# Modiste (CEPZ) Ltd.

Plot 1-4, Sector #6, Export Processing Zone, Chittagong

22 June 2014

## Apparently Non-Engineered Escape Stairs

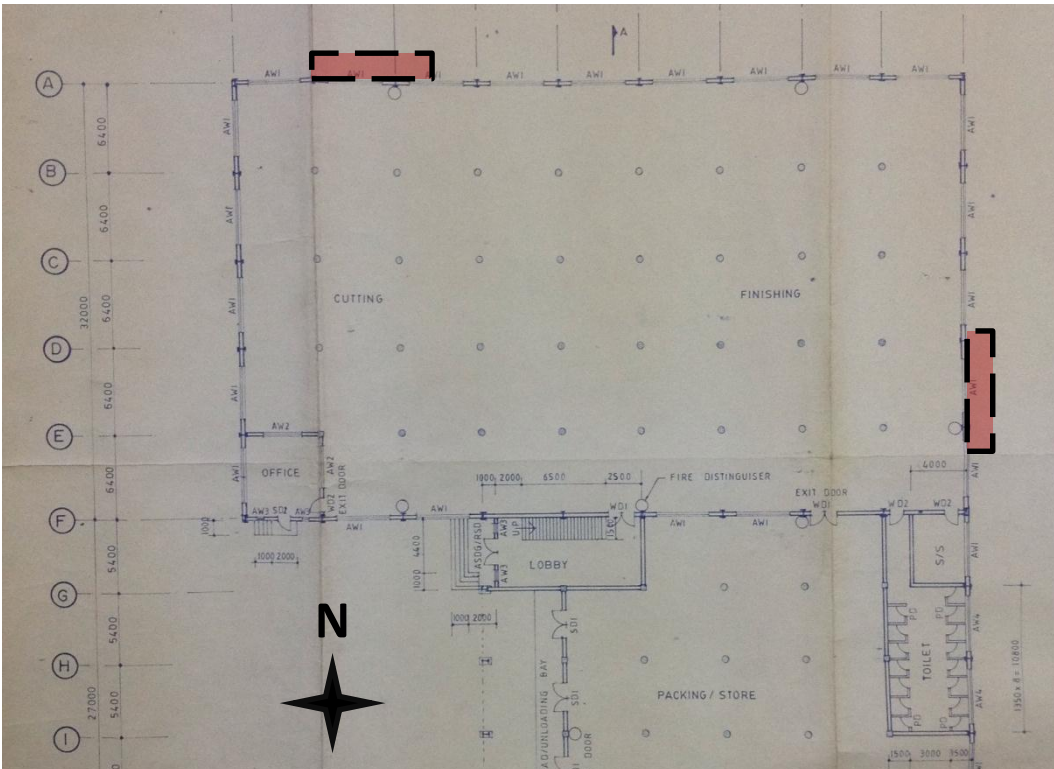
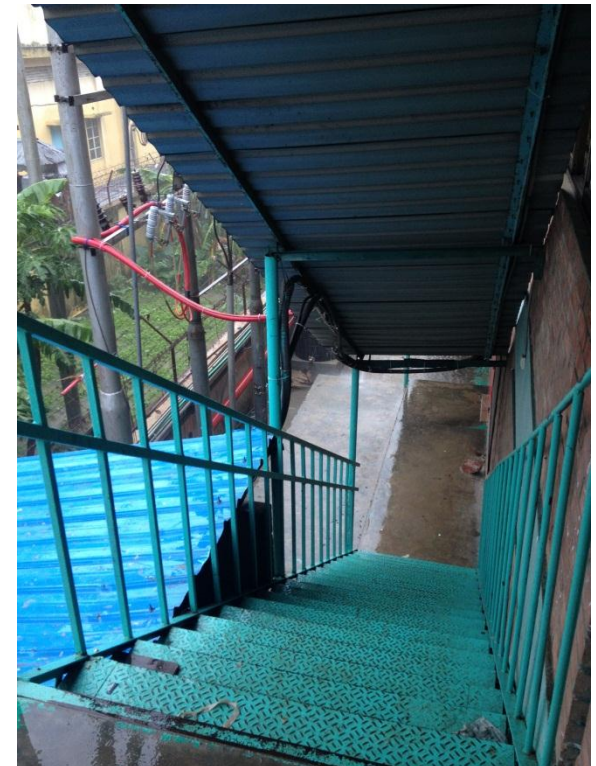
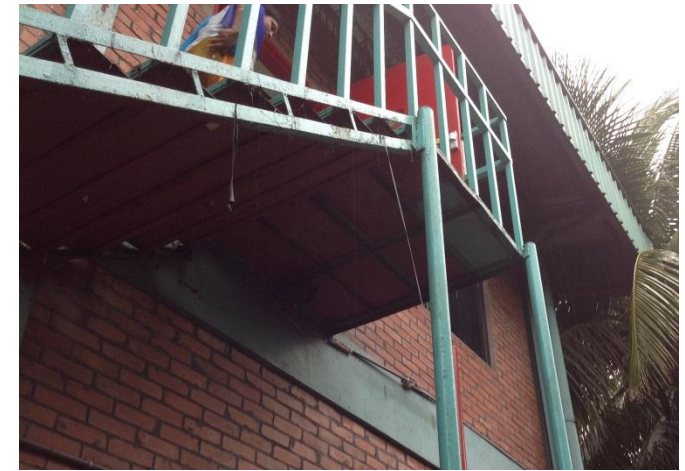
**External steel escape stairs appear  
non-engineered**

External staircases to First Floor of Building 1 intended as emergency exit routes appear non-engineered . Connections and treads appear weak and insubstantial – the stairs may not have been engineered to carry the full load during an evacuation event.

| Item No. | Observation                                                        | Recommended Action Plan                                                                                                                                                                      | Recommended Timeline |
|----------|--------------------------------------------------------------------|----------------------------------------------------------------------------------------------------------------------------------------------------------------------------------------------|----------------------|
| 1        | External steel escape stairs appear non-engineered                 | The stairs should be surveyed and assessed in detail by a structural engineer for adequacy to support the expected loading in an evacuation event and strengthened or replaced as necessary. | Immediate - Now      |

**Loading Observed  
Building No.2  
First Floor**

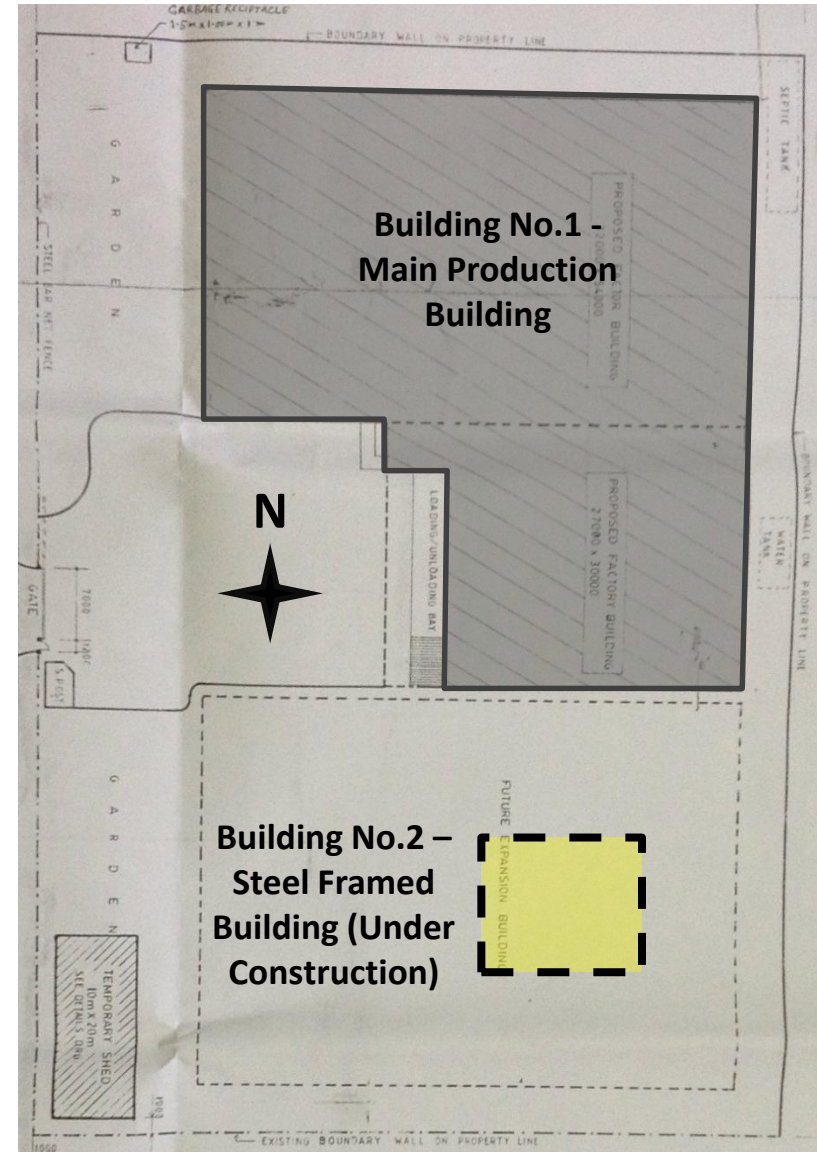
**2m High Rolled  
Unworked Fabric,  
Live Load  $7\text{kN/m}^2$**

**1.8m High Rolled Unworked Fabric,  
Live Load  $6.3\text{kN/m}^2$**

**Localised areas of high loading observed in Building 2**

| Item No. | Observation                                                        | Recommended Action Plan                                                                                                                                                                      | Recommended Timeline |
|----------|--------------------------------------------------------------------|----------------------------------------------------------------------------------------------------------------------------------------------------------------------------------------------|----------------------|
| 2        | Localised areas of high loading observed in Building 2             | Stored materials to be spread apart such that the total live load is limited to no more than 350kg/m <sup>2</sup> in accordance with the structural design.                                  | 6-weeks              |
| 3        | Localised areas of high loading observed in Building 2             | Loading plans for buildings to be correctly implemented throughout Buildings 1, 2 and 3.                                                                                                     | 6-months             |

## Loading Observed Building No.2 Second Floor

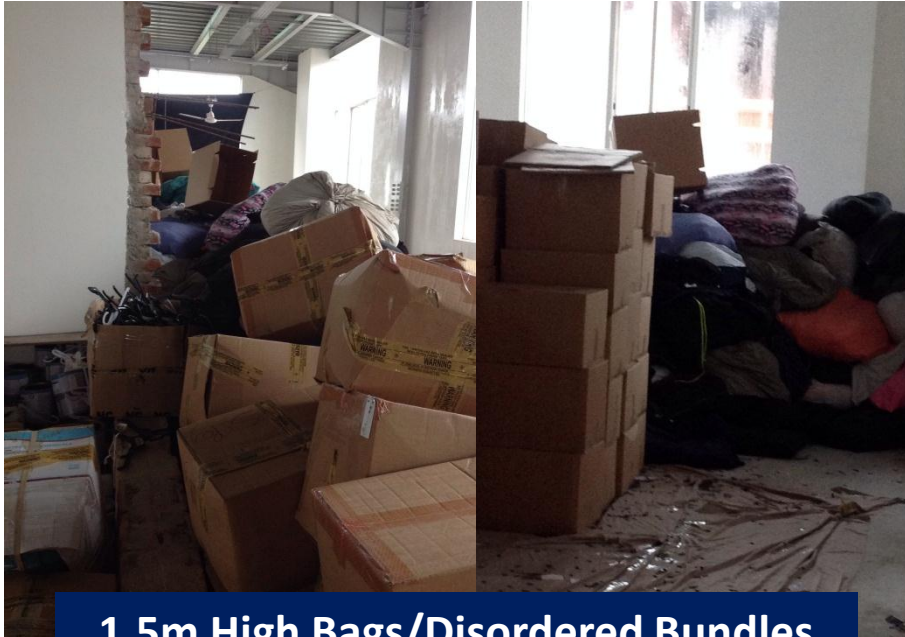
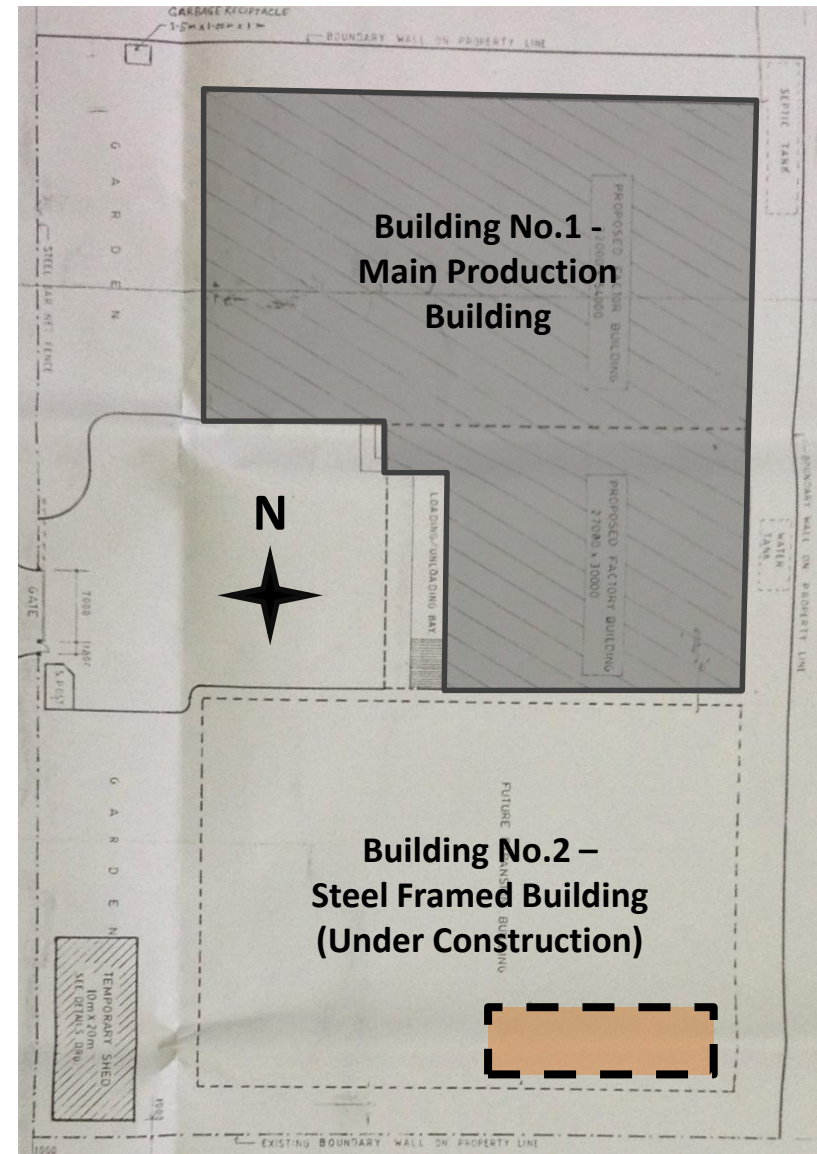
**1.5m High Bags/Disordered Bundles  
and Stacked Boxes of Clothes,  
Live Load up to  $4\text{kN/m}^2$**

**Localised areas of high loading observed in Building 2**

**Building No.2**  
**Design Live Load indicated to be 3.5kN/m<sup>2</sup>**

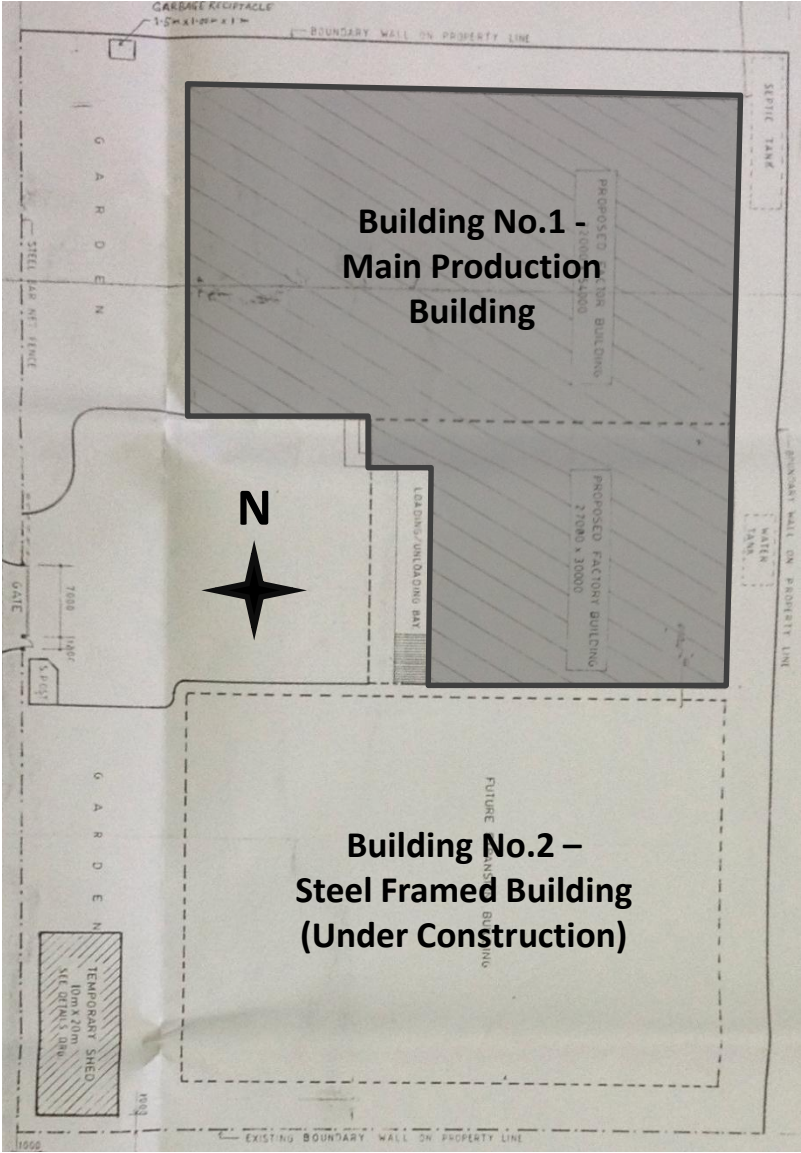
**Localised areas of high loading observed in Building 2**

## Apparently non-engineered Canteen Shed

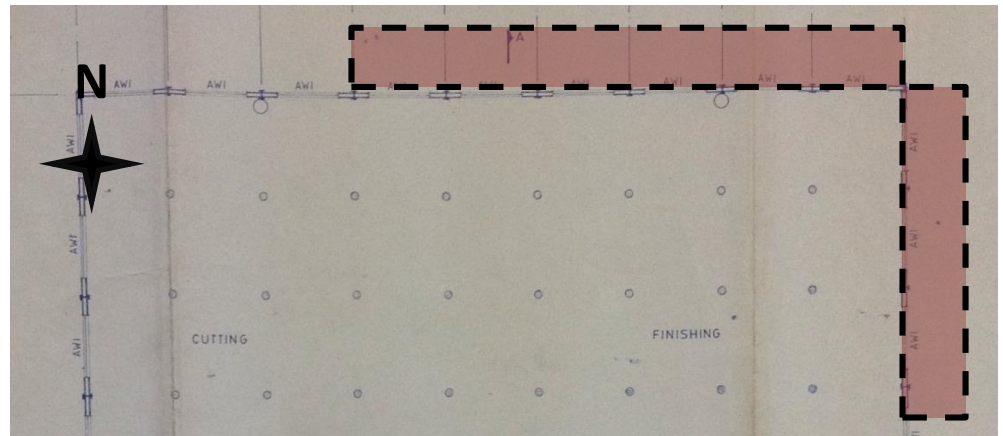
Large lightweight steel roofed canteen has been built on West face of Building 1. The structure appears non-engineered; no drawings or structural design information available. There is no obvious lateral stability system, columns appear slender. (Note – General Manager stated that canteen will be moved to third floor of Building 3 once fit-out of the new kitchens has been completed - est. July 2014)

| Item No. | Observation                                                        | Recommended Action Plan                                                                                                                                                                      | Recommended Timeline |
|----------|--------------------------------------------------------------------|----------------------------------------------------------------------------------------------------------------------------------------------------------------------------------------------|----------------------|
| 4        | Undocumented and non-engineered canteen shed and utility buildings | Steel structures should be assessed to code vertical and wind loads by the Structural Engineer.                                                                                              | 6-months             |
| 5        | Undocumented and non-engineered canteen shed and utility buildings | Carry out any remedial actions as directed by the Structural Engineer.                                                                                                                       | 6-months             |

## Incomplete Lateral Stability System

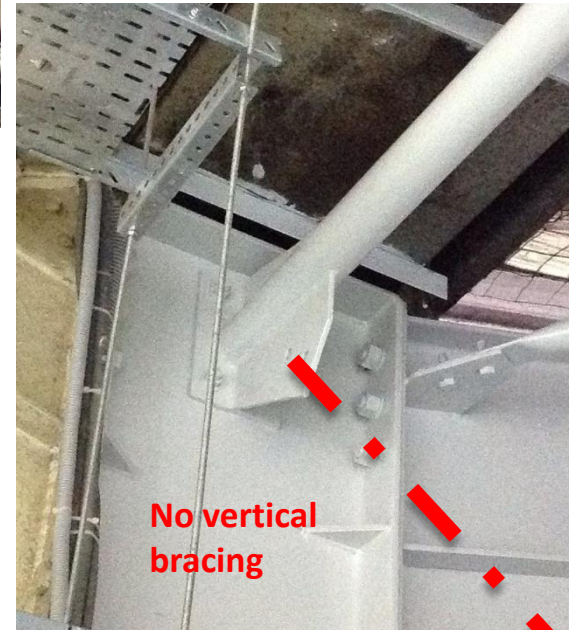
Stability system designed as braced frame in east-west direction.

No bracing provided in the vertical direction to column base.

| Item No. | Observation                                                        | Recommended Action Plan                                                                                                                                                                      | Recommended Timeline |
|----------|--------------------------------------------------------------------|----------------------------------------------------------------------------------------------------------------------------------------------------------------------------------------------|----------------------|
| 6        | Incomplete lateral stability system to Building 1                  | Structural Engineer to carry out a stability analysis of Building 1 and propose a suitable east-west lateral stability system                                                                | 6-months             |
| 7        | Incomplete lateral stability system to Building 1                  | Carry out any remedial actions as directed by the Structural Engineer.                                                                                                                       | 6-months             |

## Cracking at Beam – Column Connection

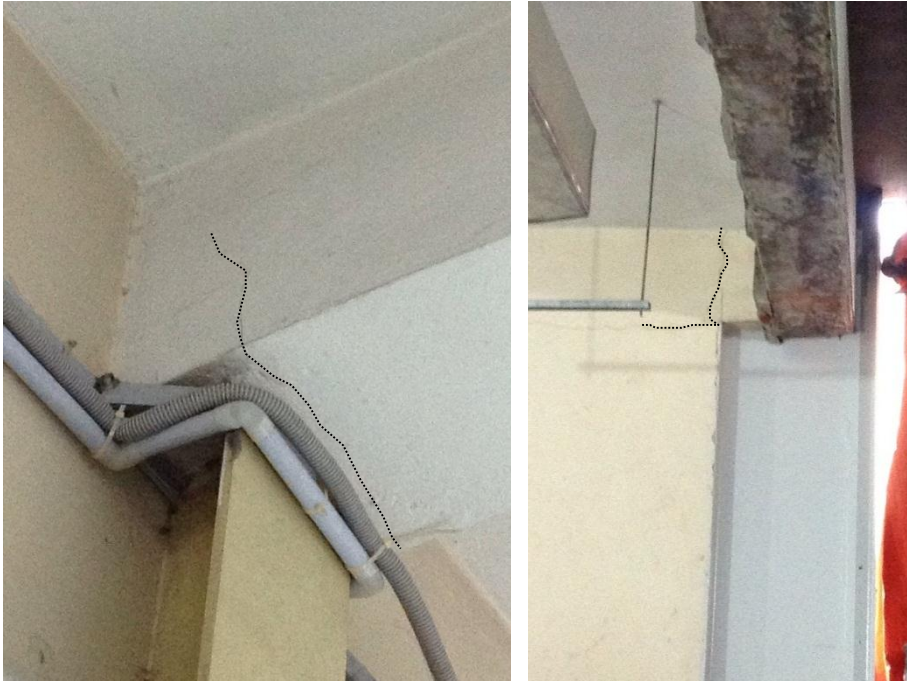
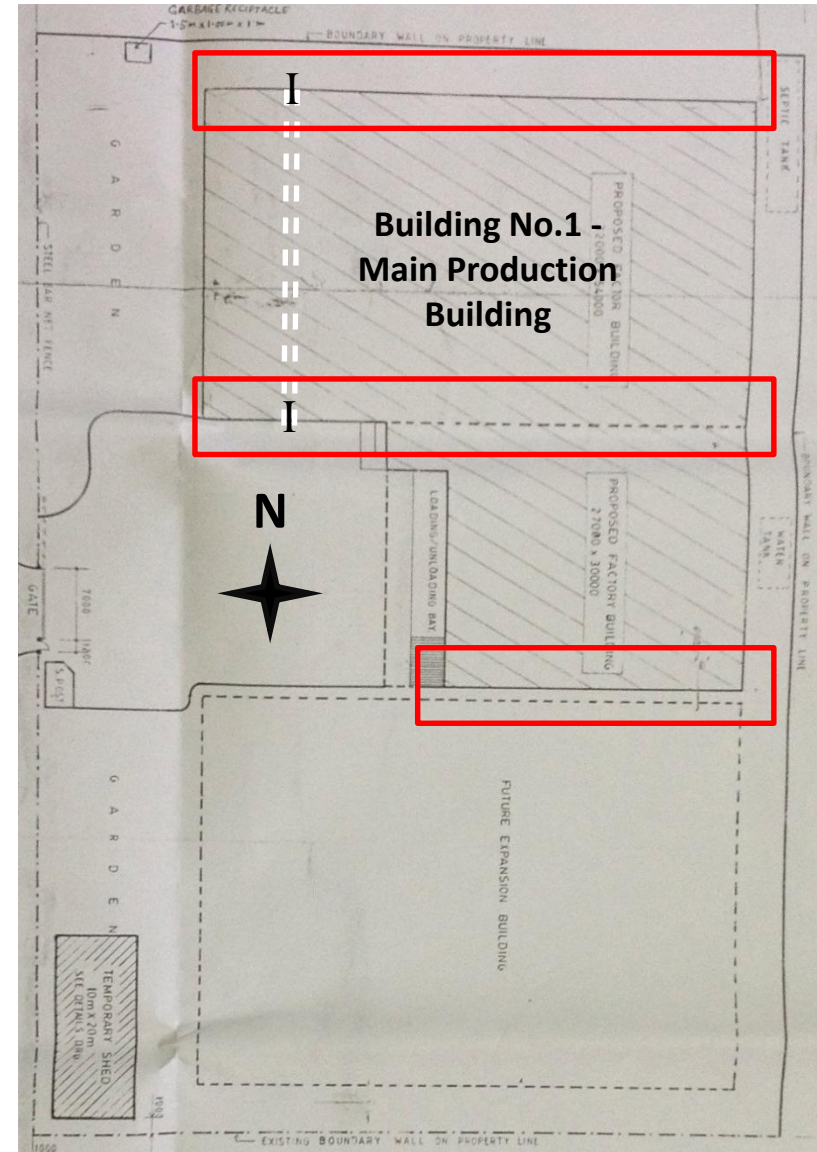
**Cracking observed at connection between  
RC beam and steel column**

Horizontal cracking observed at the RC Beam to Steel Column connection.  
Observed in a large number of connections.  
No standard drawing/detail provided showing connection type.

| Item No. | Observation                                                          | Recommended Action Plan                                                                                       | Recommended Timeline |
|----------|----------------------------------------------------------------------|---------------------------------------------------------------------------------------------------------------|----------------------|
| 8        | Cracking observed at the connection between RC beam and steel column | Structural Engineer to assess the as-built connection detail provided between concrete beam and steel column. | 6-months             |
| 9        | Cracking observed at the connection between RC beam and steel column | Retrofitting to be carried out as directed by the Structural Engineer.                                        | 6-months             |

## Movement Joint

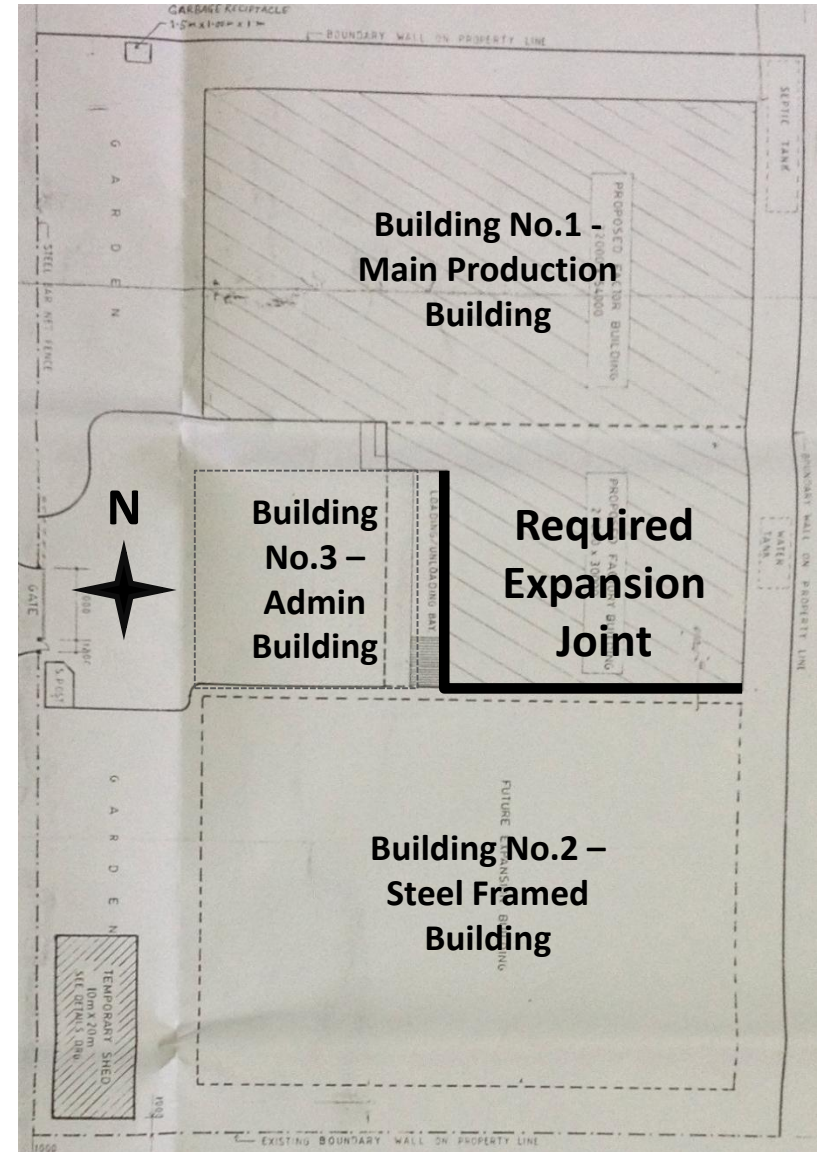
**Movement joint between  
Building 1 and 3 is discontinuous**

Existing movement joint between Building No.1 and 3

| Item No. | Observation                                                          | Recommended Action Plan                                                                                       | Recommended Timeline |
|----------|----------------------------------------------------------------------|---------------------------------------------------------------------------------------------------------------|----------------------|
| 10       | Movement joint between Buildings 1 and 3 is discontinuous            | Structural Engineer to determine the location of the interface between Building 1 and 3.                      | 6-months             |
| 11       | Movement joint between Buildings 1 and 3 is discontinuous            | Form a properly detailed expansion joint between both buildings as directed by the Structural Engineer.       | 6-months             |
